# CAMDEN CROSSING

Submitted for Site Plan Review  
 9.36 ACRE DEVELOPMENT  
 Rochester Hills, Oakland County, Michigan

**Subject: Camden Crossing Site Condominiums;  
Wetland Use Permit Review #4;  
Plans dated October 23, 2025  
ASTI File No. A25-0125.10**

# Site plan.pdf Markup Summary

**1 REGULATED TREE IDENTIFICATION PLAN** SCALE: 1" = 60' - 0"

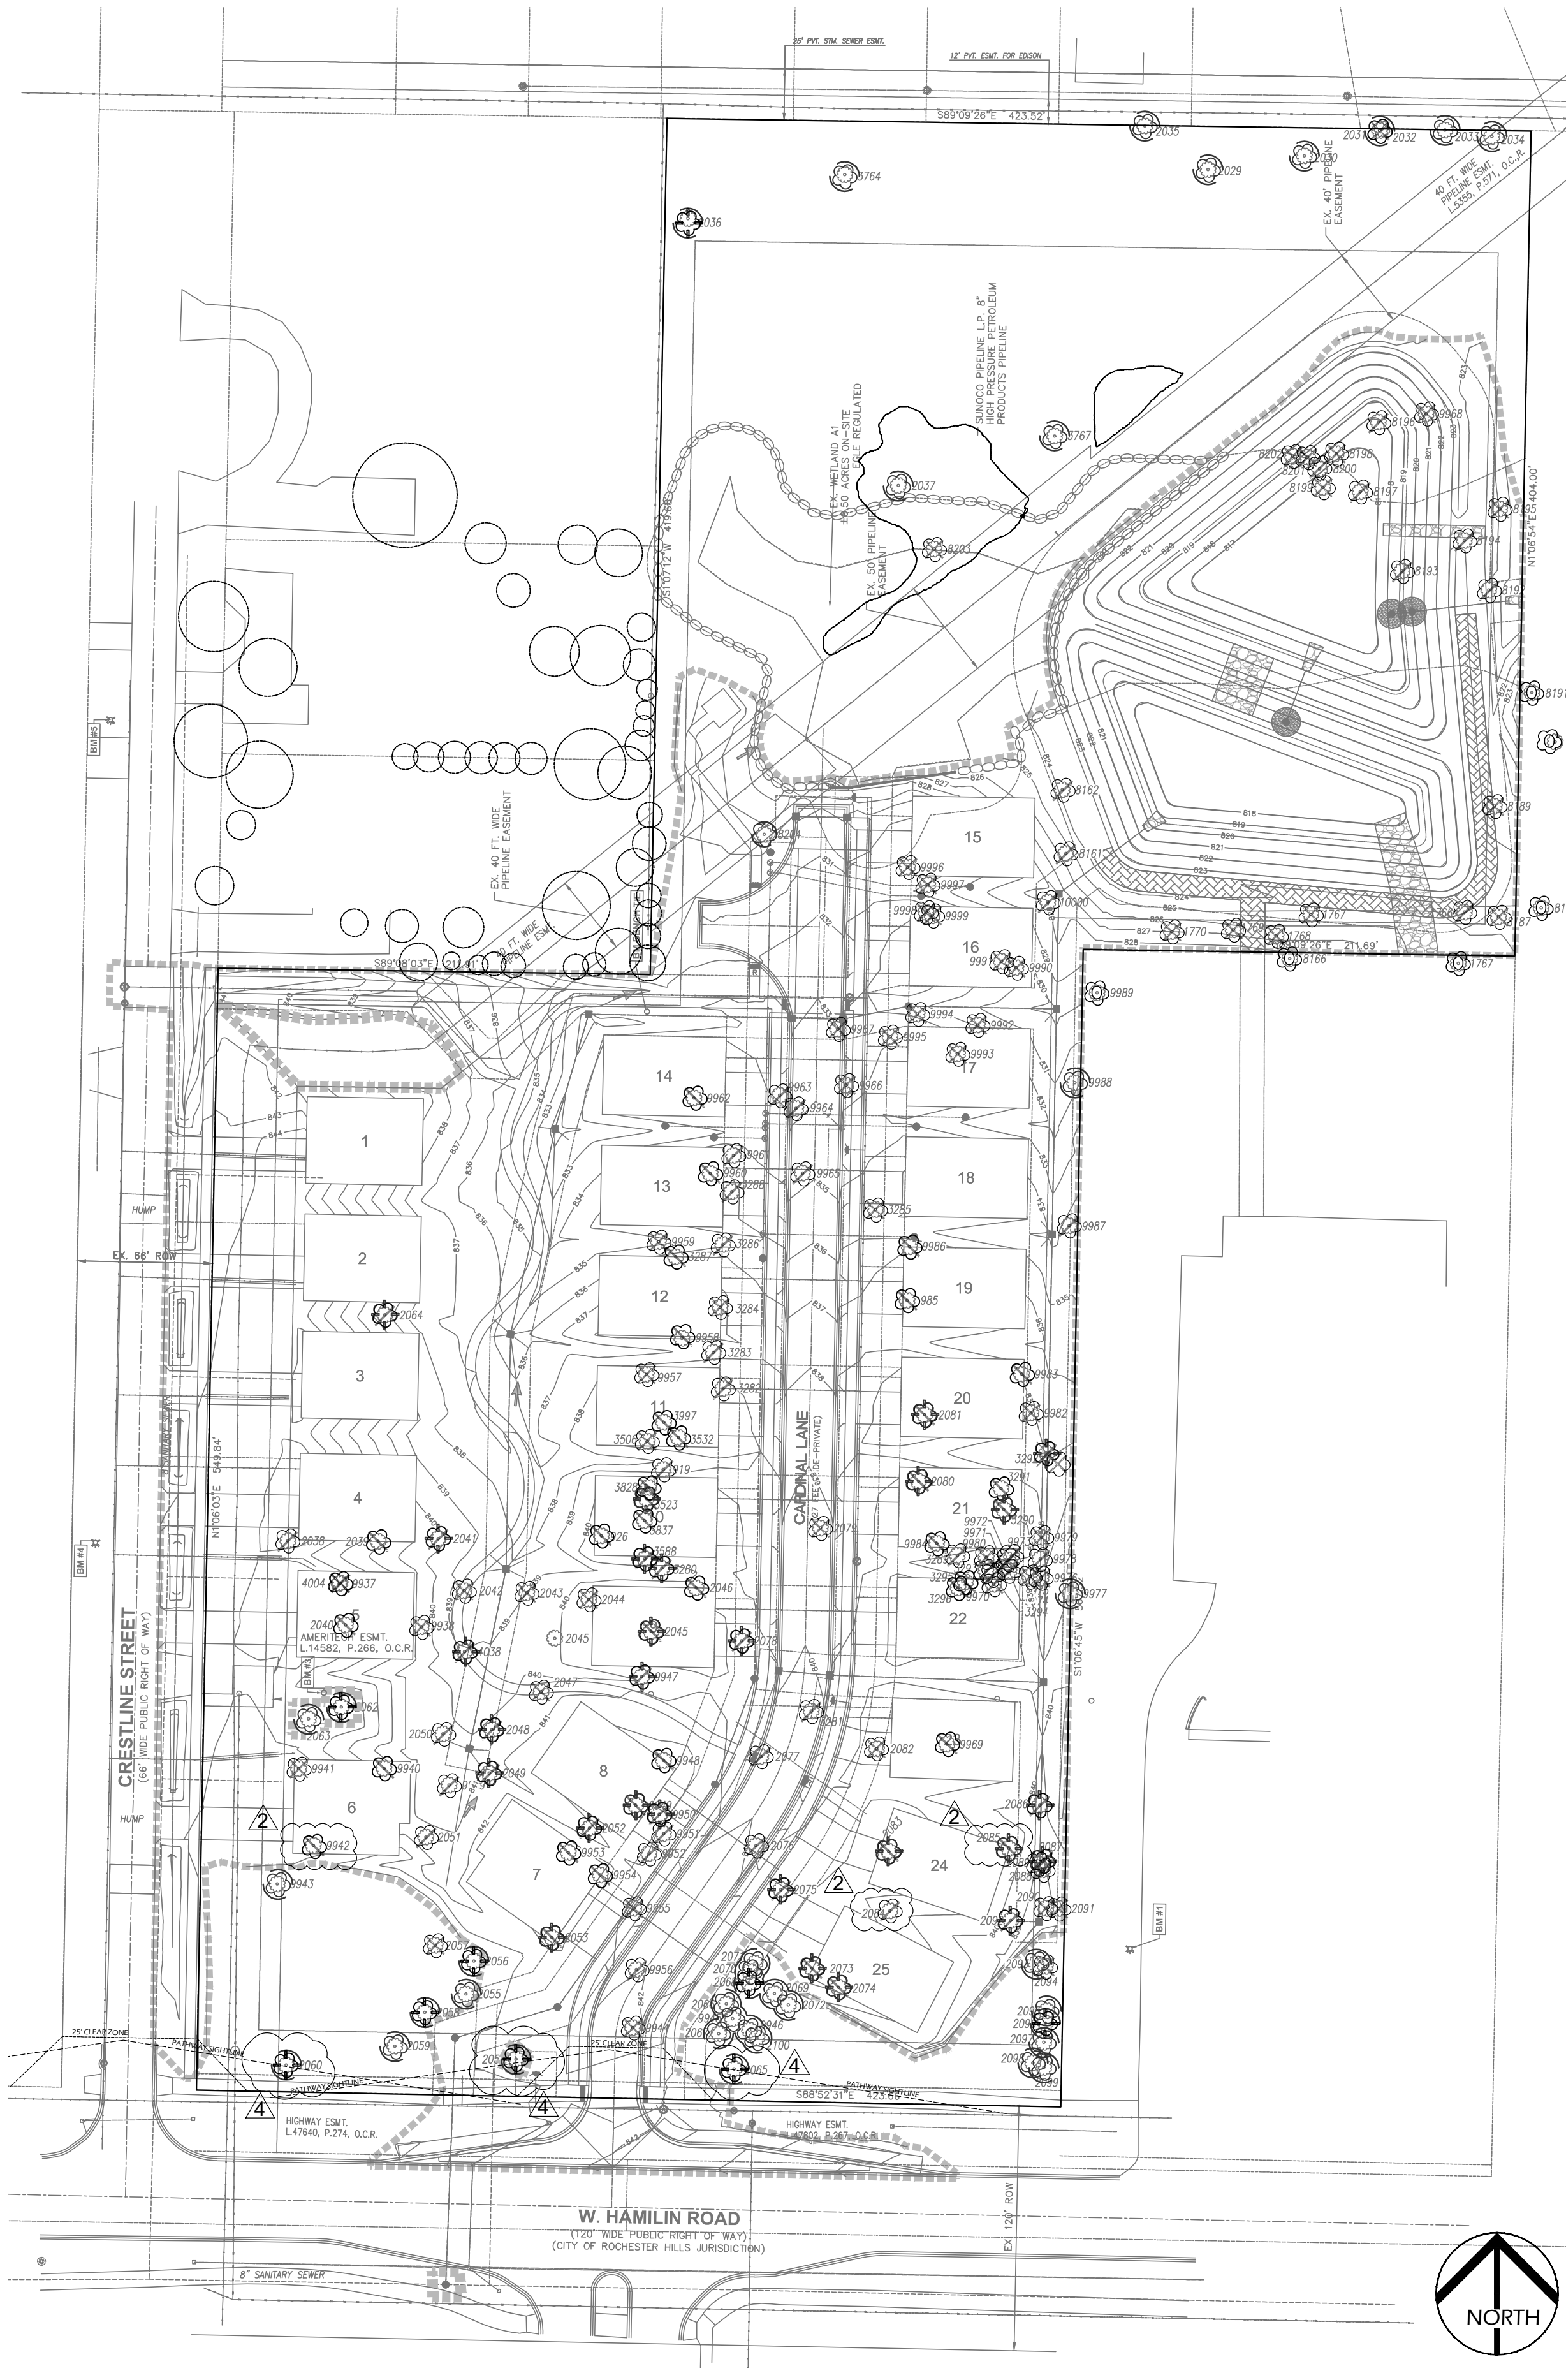
**NOTE:** EXISTING PRESERVED TREES (TAG NO. 2060, 2054 AND 2065) THAT OVERHANGING THE PATHWAY SIGHTLINE MUST BE PRUNED TO ELIMINATE ANY BRANCH AND OR LIMBS FROM GROUND LEVEL TO 10 FEET ABOVE GROUND LEVEL.

LANDSCAPE PLANTING PLAN

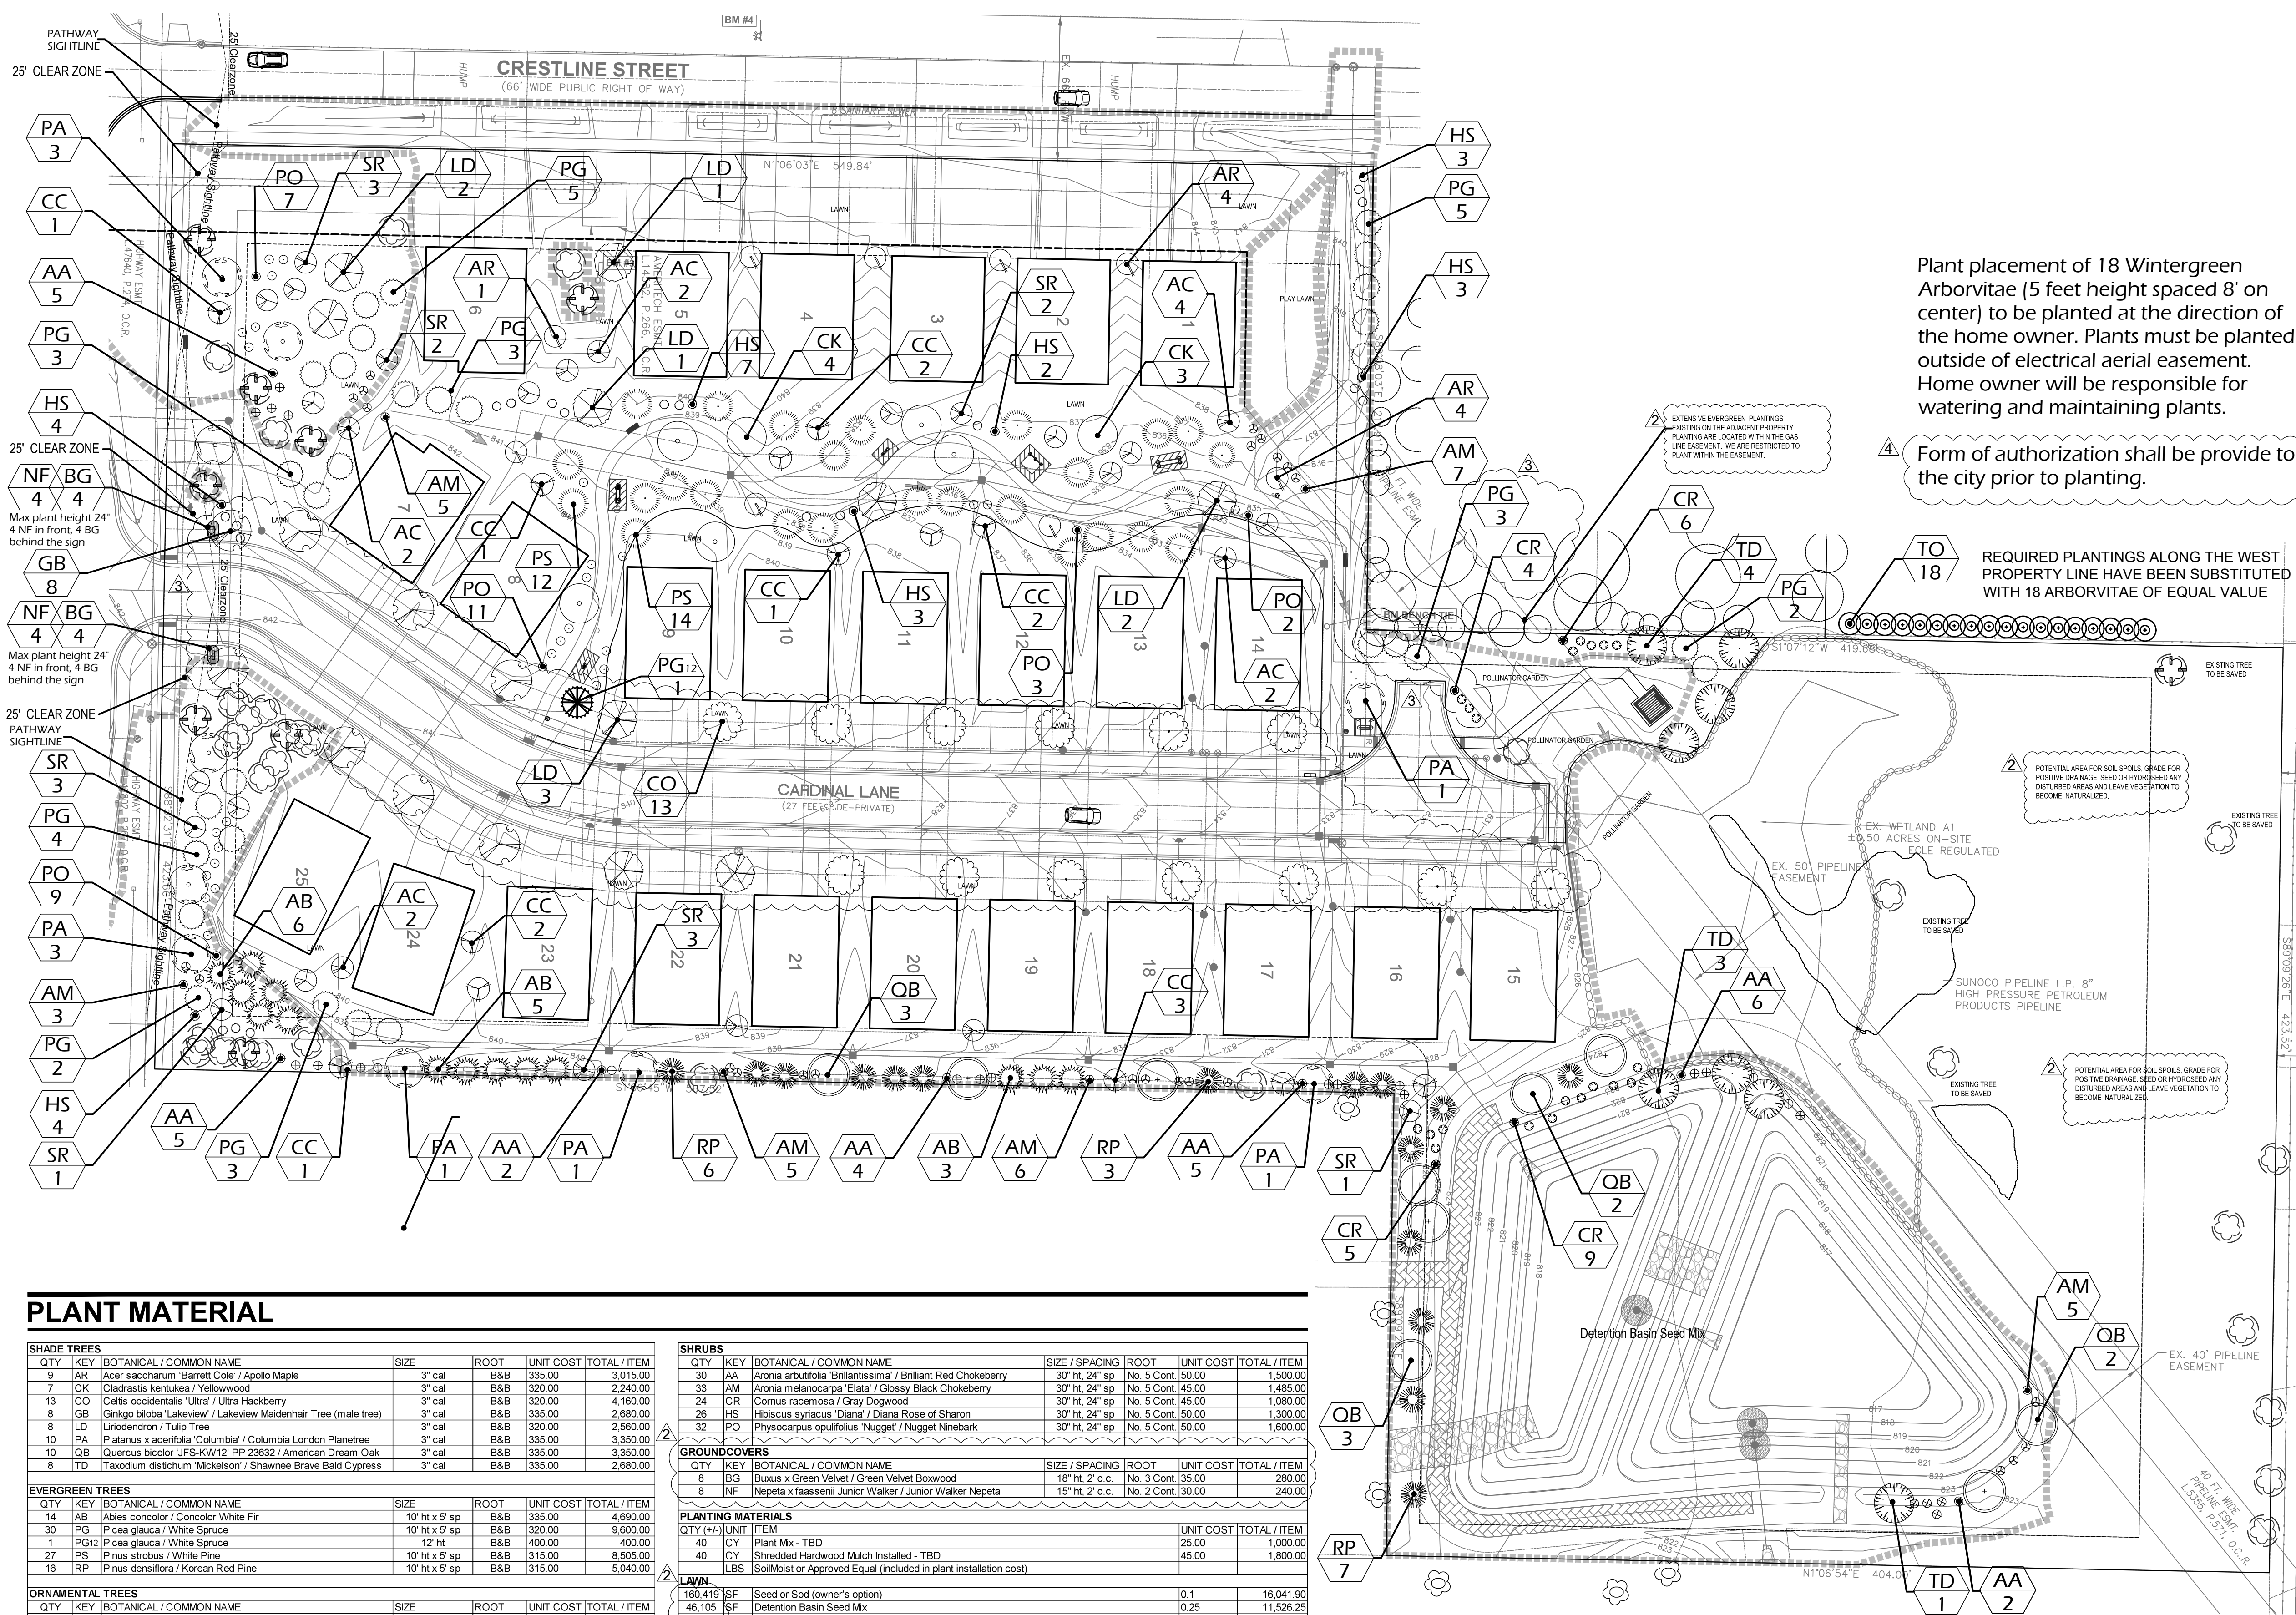
Form of authorization shall be provided prior to planting.  
REQUIRED PLANTINGS ALONG THE  
HAVE BEEN SUBSTITUTED WITH 18"  
EQUAL VALUE

Form of authorization shall be provided prior to planting.

Plant placement of 18 Wintergreen Arborvitae (5 feet height spaced 8' on center) to be planted at the direction of the home owner. Plants must be planted outside of electrical aerial easement. Home owner will be responsible for watering and maintaining plants.

Form of authorization shall be provide to the city prior to planting.
